**ENVIRONMENTAL IMPACT STATEMENT**  
**ON**  
**CONTINUED OPERATION OF THE**  
**HANFORD GENERATING PROJECT**

**WASHINGTON PUBLIC POWER SUPPLY SYSTEM**

**JANUARY 1977**

Figure 4.3-1(a)  
Thermal Exposure in Plume  
Centerline at Low River Flow

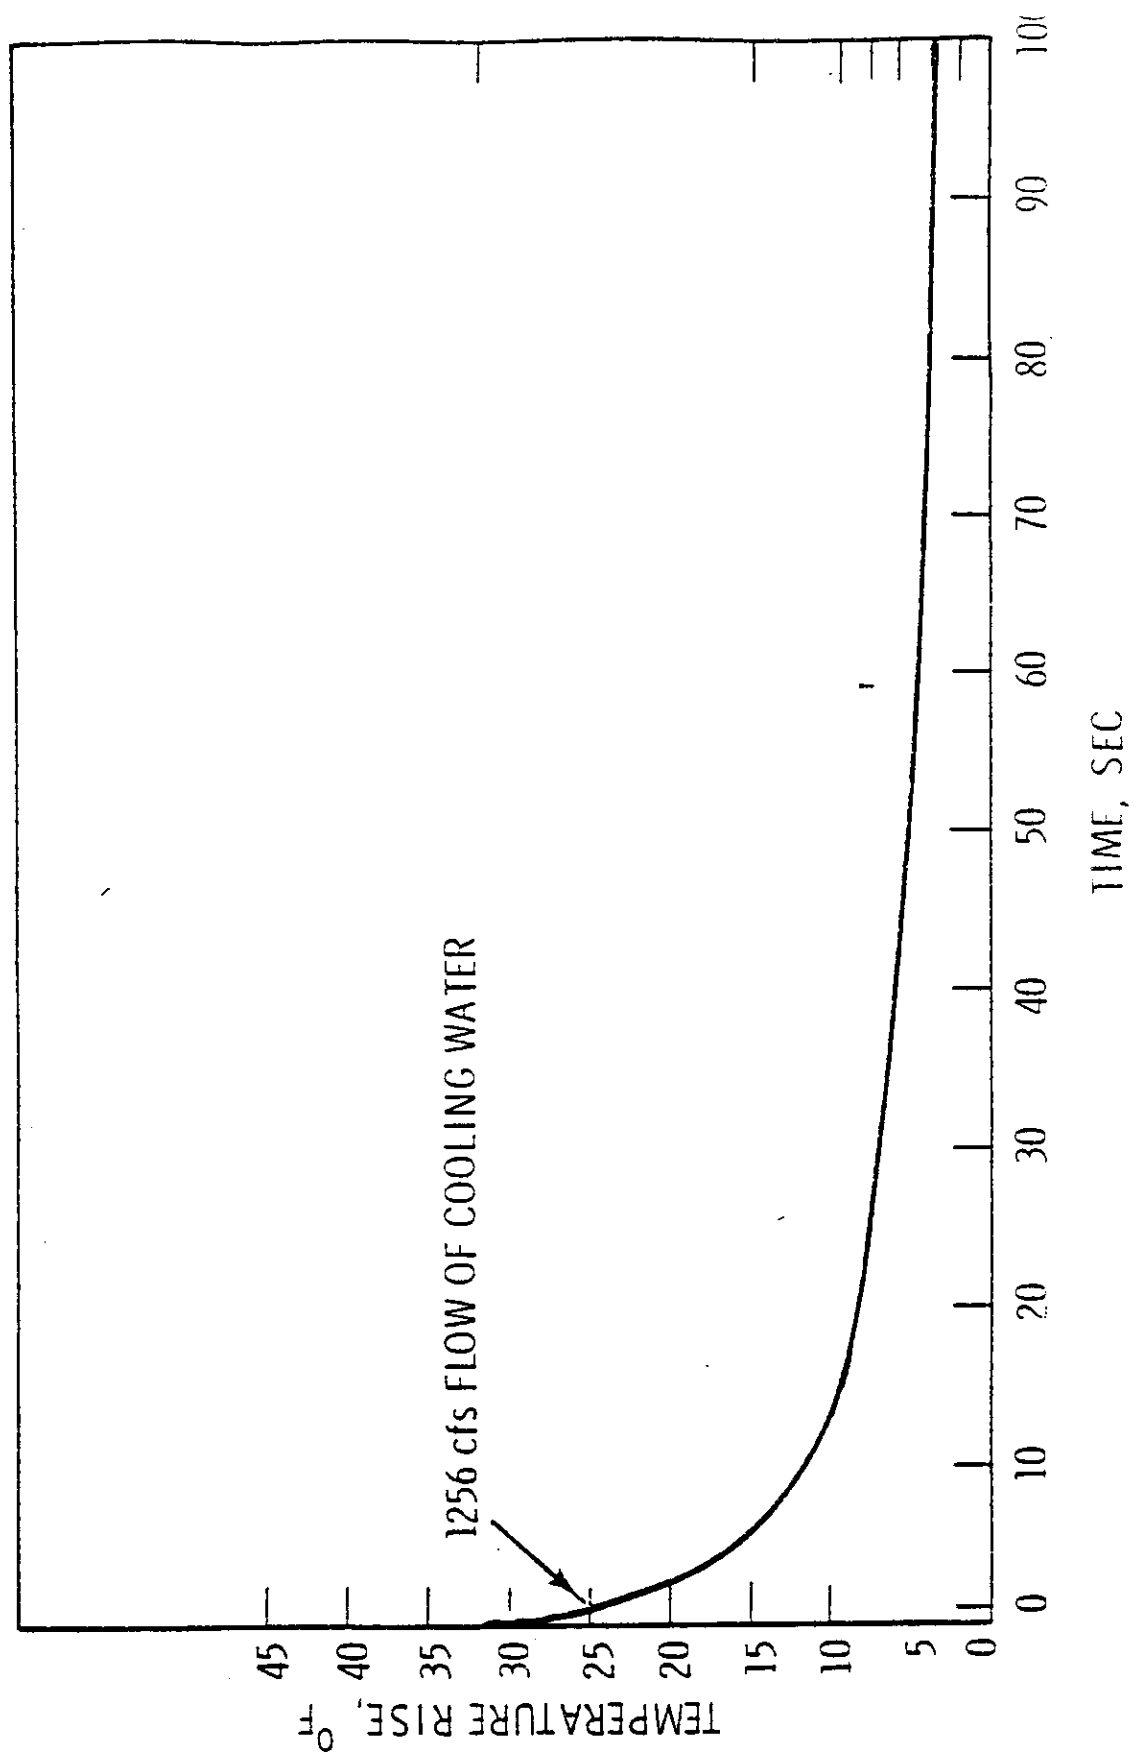
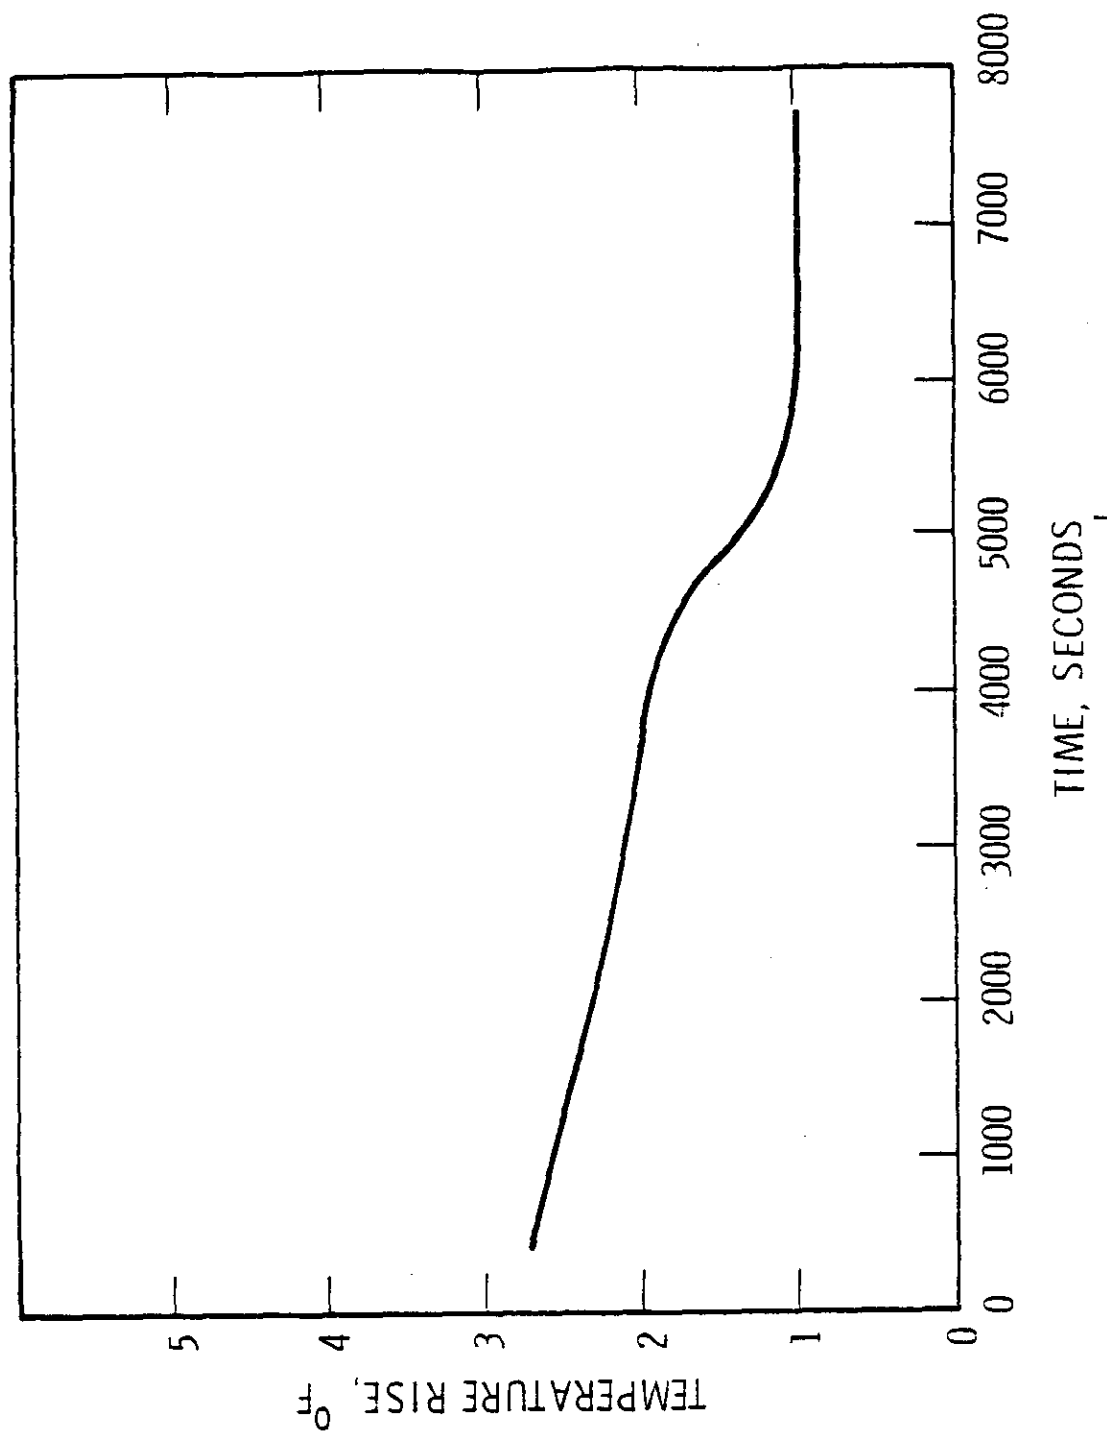
We believe that Figure 4.3-1 needs to be discussed considerably more in the DEIS. The method used to estimate the cumulative exposure time in seconds for fish should be discussed more extensively since this is a very crucial portion of the analysis. However, NMFS studies show that once temperatures exceed 29 degrees centigrade immediate tetany and cessation of respiratory movements can occur, and it is doubtful that juvenile chinook could escape from the danger area (Snyder and Blaha, August 1970).<sup>1/</sup> Mortalities to juvenile chinook can occur within a period of four seconds at 90°F.<sup>2/</sup>

11. Figure 4.3-1 was developed from field measurements and mathematical models of the HGP plume. While actual conditions may deviate slightly from the curve presented in the figure, rapid dilution has been documented by field measurements at numerous river flows.
